## ETOD Detailed Site Plan Departure from Design Standards (Two Town Center)

**DSP-20036**  
**DDS-673**

SUBJECT:      Detailed Site Plan DSP-20036  
                 Type 2 Tree Conservation Plan TCP2-038-2020  
                 Alternative Compliance AC-20012  
                 Departure from Design Standards DDS-673  
                 Two Town Center  
                 Expedited Transit-Oriented Development Project

**Figure 1: Overall Plan of Town Center at Camp Springs**

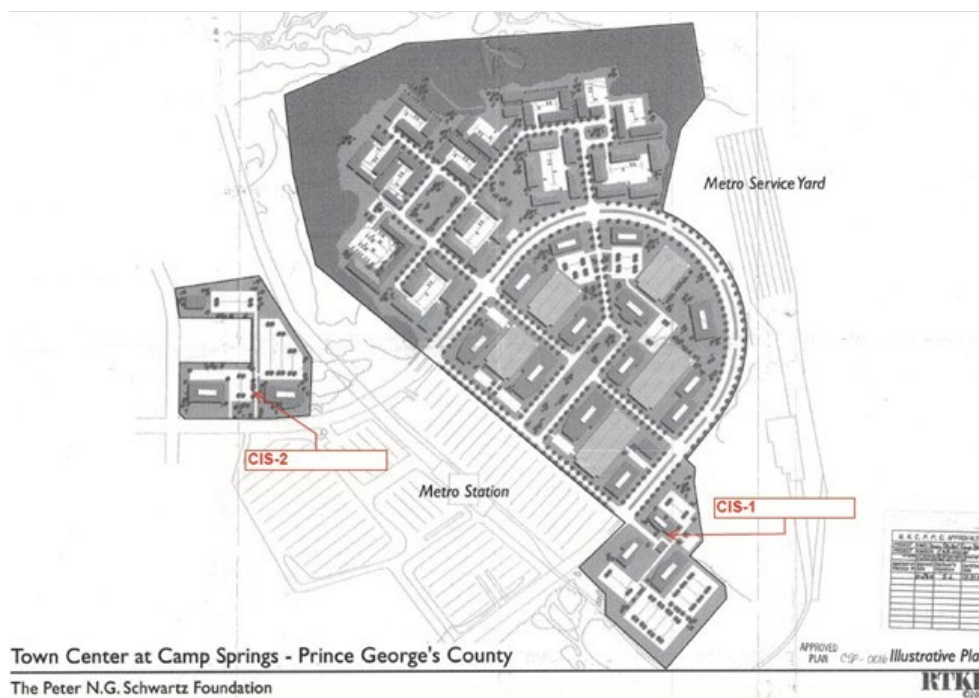
The office building is proposed as an expansion of the office, as identified as CIS-1 in Figure 1, for the U. S. Citizenship and Immigration Services (USCIS), which is a component of the United States Department of Homeland Security (DHS). USCIS will be the sole tenant to use the office building and associated parking garage included in this DSP.
